Access Compliance Report

Public Rights-of-Way

(Curb Ramps)

Intersection ID: 25709	Main Street: CHARTER_OAK_LN	Cross Street: JOHNSTON_RD	Location: NW
ADA ID: E161E256218B	Ramp Type: Perp	Initial Pass/Fail: Fail	Overall Compliance: No
Severity Score: 12.5			
Codes/Mitigation Info/Possible Solution		Field Measurements/Component Compliance

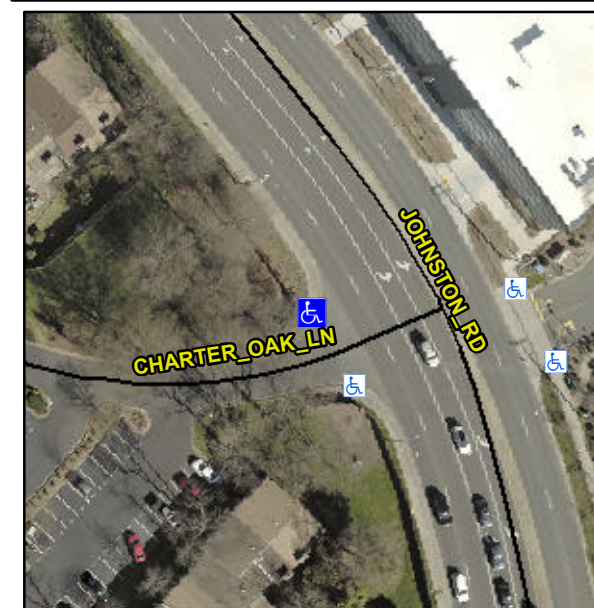
Not Found, R304.5.3

Compliance	Description	Data	Compliance	Description	Data
N/A	Ramp Length (in)	60.0	Yes	Ramp Slope (%)	7.6
Yes	Ramp Width (in)	48.0	No	Ramp XSlope (%)	5.9
N/A	Flare Type LT	N/A	N/A	Flare Type RT	N/A
N/A	Flare Slope LT (%)	N/A	N/A	Flare Slope RT (%)	N/A
N/A	Flare Traversable LT?	N/A	N/A	Flare Traversable RT?	N/A
N/A	Landing Length (in)	N/A	N/A	DWS Provided?	N/A
N/A	Landing Width (in)	N/A	N/A	DWS Contrast?	N/A
N/A	Landing Slope (%)	N/A	N/A	DWS Length (in)	N/A
N/A	Landing X Slope (%)	N/A	N/A	DWS Full Width?	N/A
N/A	Landing Curb? (Y/N)	N/A	N/A	DWS Offset (in)	N/A
N/A	Shared Landing?	N/A			
N/A	Gutter Ponding?	N/A	N/A	Gutter Slope (%)	N/A
N/A	Gutter Lip Ht (in)	N/A	N/A	Gutter X Slope (%)	N/A
N/A	Painted X Walk1?	No	N/A	Painted X Walk2?	N/A
	X Walk 1 Direction	To SE		X Walk 2 Direction	N/A
N/A	X Walk 1 Width (in)	N/A	N/A	X Walk 2 Width (in)	N/A
	X Walk 1 Slope (%)	1.6		X Walk 2 Slope (%)	N/A
	X Walk 1 X Slope (%)	6.7		X Walk 2 X Slope (%)	N/A

Remove & Replace Entire Ramp.
